# UNITED STATES PATENT AND TRADEMARK OFFICE

APPLICATION NO.	FILING DATE	FIRST NAMED INVENTOR	ATTORNEY DOCKET NO.	CONFIRMATION NO.
10/797,950	03/10/2004	Toru Takeuchi	42530-6800	4866

**Office Action Summary**

FIG. 10

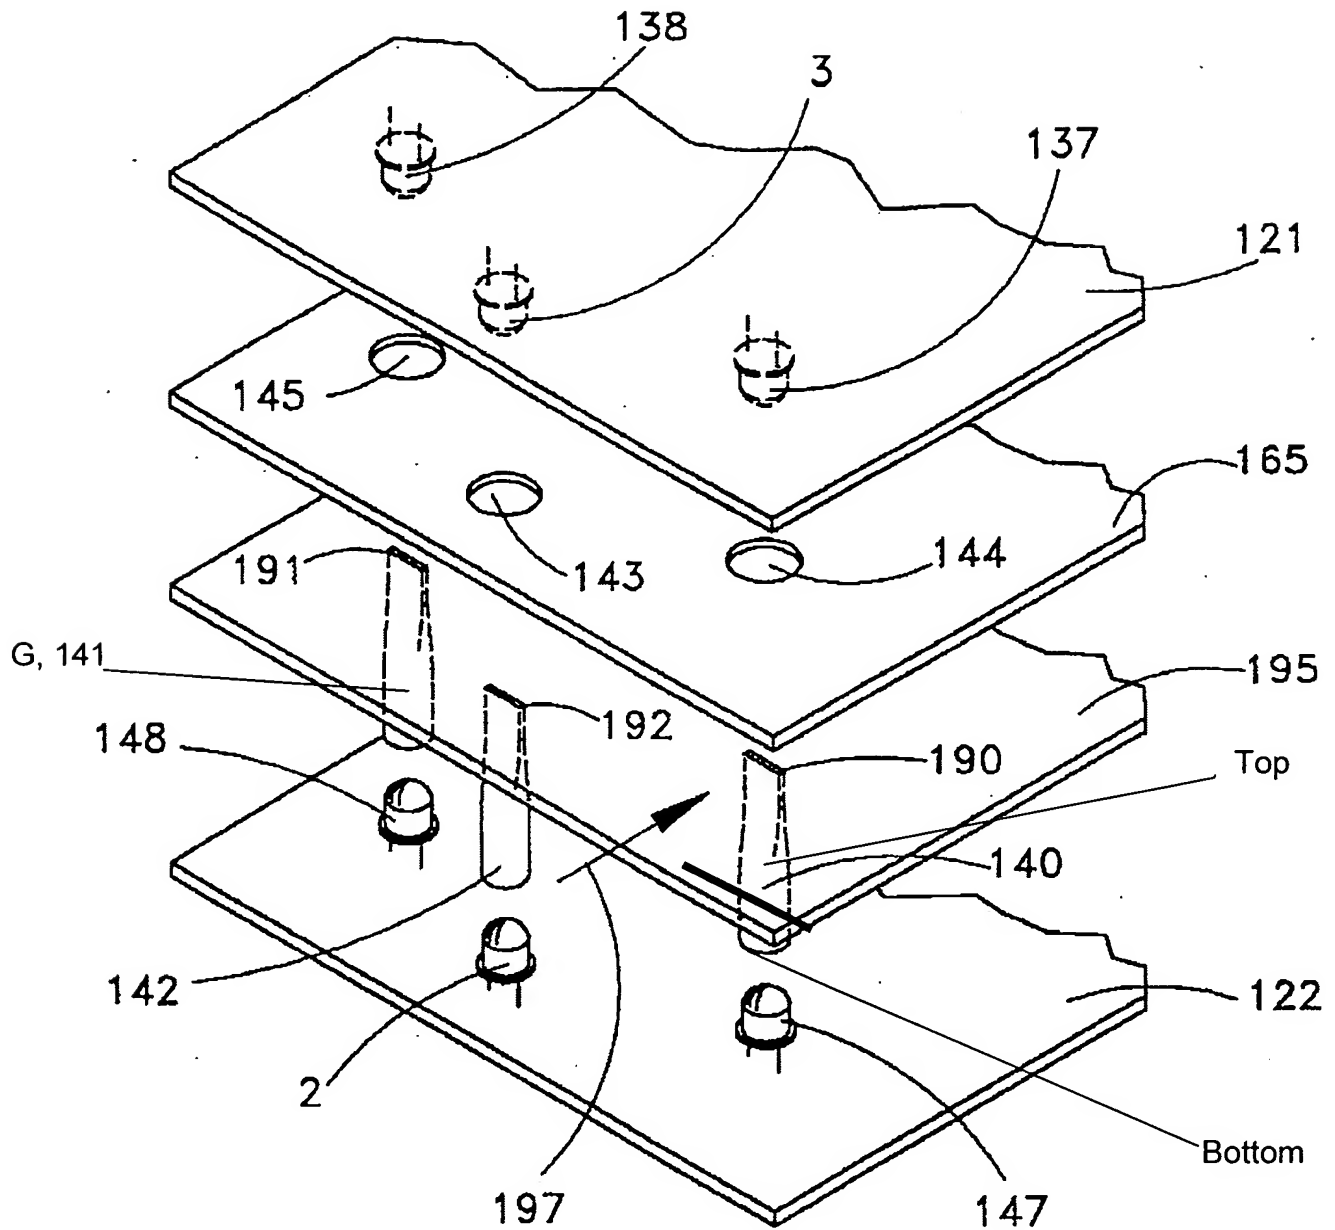
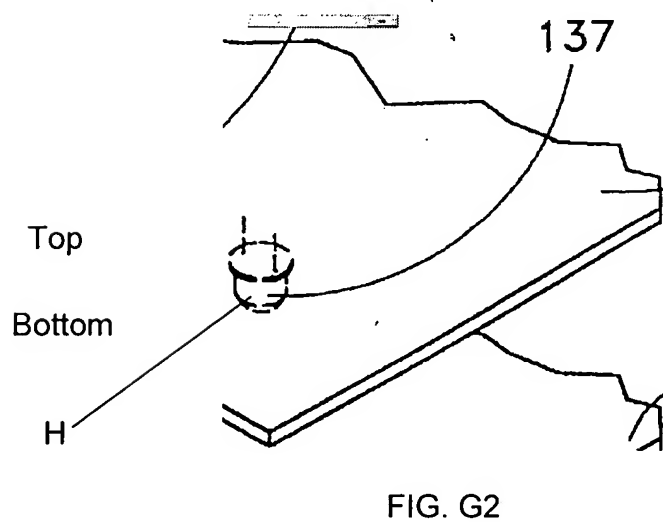
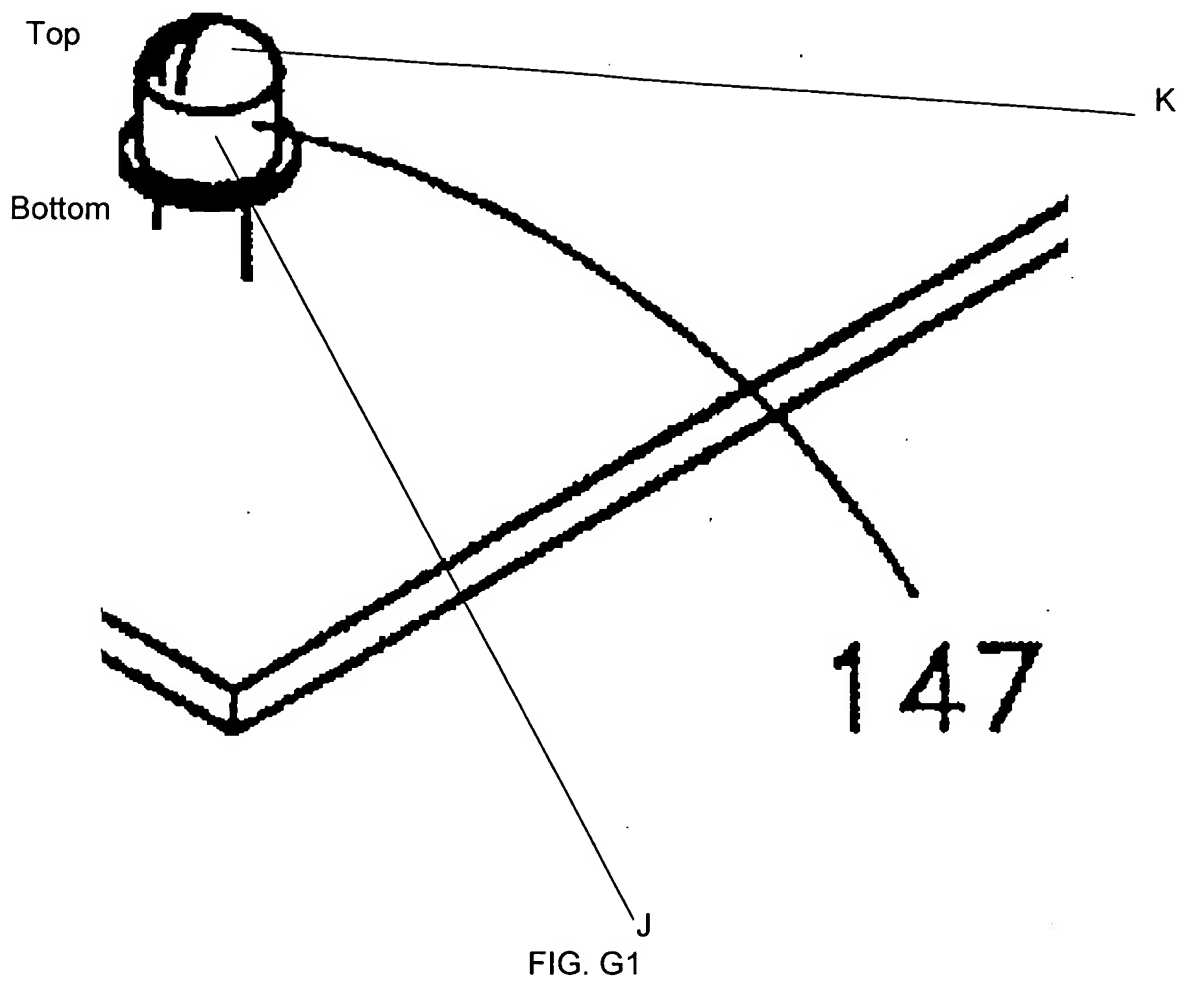
Claim 1: banknote storing unit (21, 22); banknote receiving unit (103); moving unit (M2); optical guide units (See FIG. 10 below, 140, 142, G); projecting surface (190-192); receiving surface (See FIG. 10 below, 140, 142, G); portion (See FIG. 10 below: where 140, 142, and G meet 122); surface (195); optical emitter-receiver pair units (See FIG. 10: 2, 147, 148; 3, 137, 138);

Claim 2: detecting projecting surface (See FIG. 10 below: top of 140, 142, and G); receiver section (See FIG. 10 below, curved sections of 3, 137, 138); optical emitter-receiver pair unit (See FIG. 10: 2, 147, 148; 3, 137, 138); detecting receiving surface (See FIG. 10 below: bottom of 140, 142, and G); emitter section (See FIG. 10 below, curved sections of 2, 147, 148);

Claim 3: detecting projecting surface (190-192); position detecting optical guide unit (See FIG. 10 below, 140, 142, G); light beam (column 8, lines 40-49); emitter section (See FIG. 10 below, curved sections of 2, 147, 148); position detecting emitter-receiver pair unit (See FIG. 10: 2, 147, 148; 3, 137, 138); reflector member (See FIG. 10 below: top of 140, 142, and G);

Claim 6: detecting projecting surface (See FIG. 10 below: top of 140, 142, and G); detecting receiving surface (See FIG. 10 below: bottom of 140, 142, and G);

Claims 9: **optical guide unit** (140); **first column** (See FIG. 10 below, top of 140); **second column** (See FIG. 10 below, bottom of 140); **first end of the first column** (See FIG. 10 below, bottom end of top of 140); **first reflecting surface** (See FIG. 10 below, bottom end cross section of top of 140); **first end of the second column** (See FIG. 10 below, top end of bottom of 140); **second reflecting surface** (See FIG. 10 below, top end cross section of bottom of 140); **side surface of the first column** (See FIG. 10 below, inside surface of top of 140); **detecting projecting section [sic]** (190); **side surface of the second column** (See FIG. 10 below, inside surface of bottom of 140); **detecting receiving section [sic]** (See FIG. 10 below, inside surface of bottom of 140); **projecting surface** (See FIG. 10 below, bottom surface of the bottom of 140);

Claim 11: **light emitting element** (147); **light** (column 8, lines 40-49); **first cylinder** (See FIG. G1 below, J); **first end of the first cylinder** (See FIG. G1 below, top of J); **second end of the first cylinder** (See FIG. G1 below, bottom of J); **light detecting element** (137); **second cylinder** (See FIG. G2 below, H); **second end of**

**the first cylinder** (See FIG. G2 below, bottom of H); **portion of light** (144 and column 8, lines 40-49); **second end of the second cylinder** (See FIG. G2 below, top of H);

Claim 12: second end of the first column (See FIG. 10 below, bottom end of bottom of 140); projecting surface (See FIG. 10 below, bottom surface of the bottom of 140);

Claim 24: projecting and receiving unit (2, 3); cylinders (See FIG. G1 below, J; See FIG. G2 below, H); first cylinder (See FIG. G1 below, J); one end of the light emitting element (See FIG. G1 below, top of J); second cylinder (See FIG. G2 below, H); one end of the photo-detection element (See FIG. G2 below, bottom of H);

Claim 25: optical guide assembly (142); first reflecting surface (See FIG. 10 below, bottom end cross section of top of 140); second reflecting surface (See FIG. 10 below, top end cross section of bottom of 140); light projecting section (2); light receiving section (3);

Claim 29: first and second cylinder (See FIG. G1 below, J; FIG. G2 below, H; respectively); one piece (See FIG. G1 below, J; FIG. G2 below, H);
